# Certificate of Appropriateness

### **1119 E. Knapp Street, First Ward Triangle Historic District**

## Date issued 11/12/2025

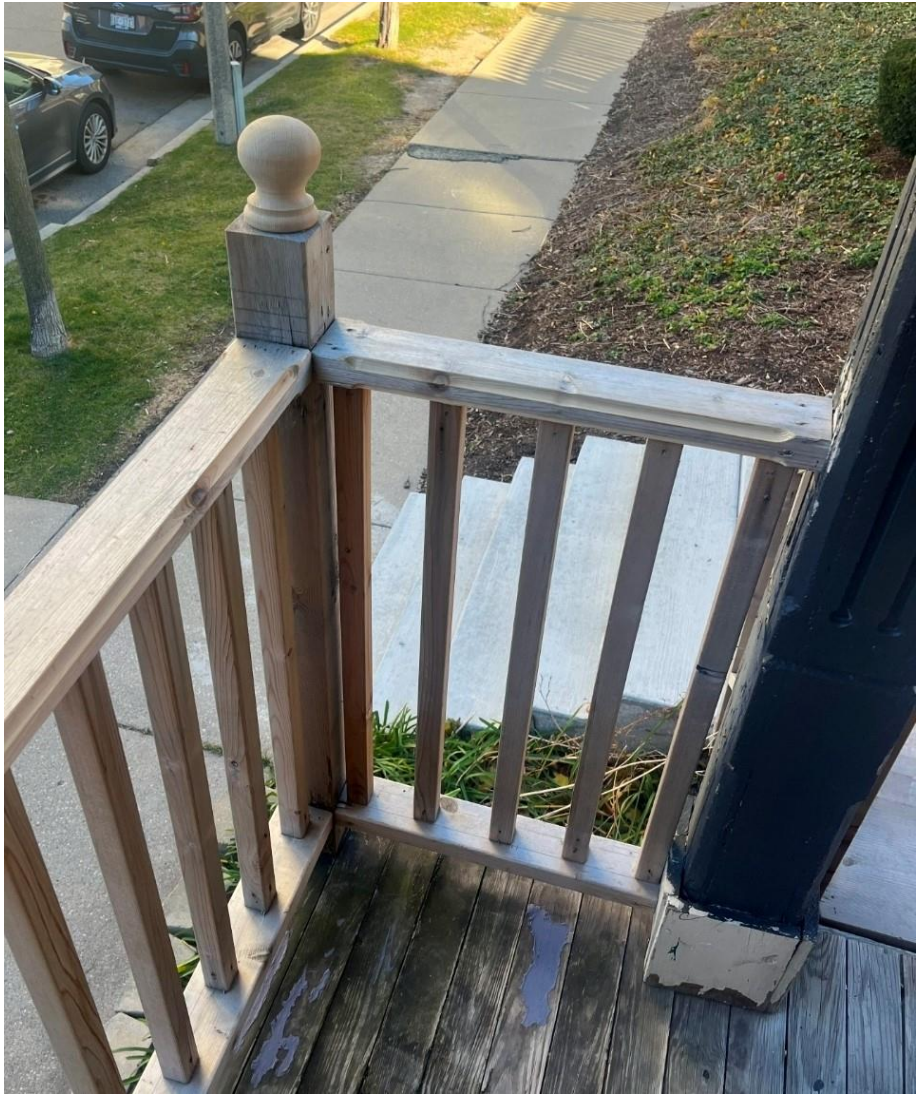
Molded top rail will be duplicated on bottom rail
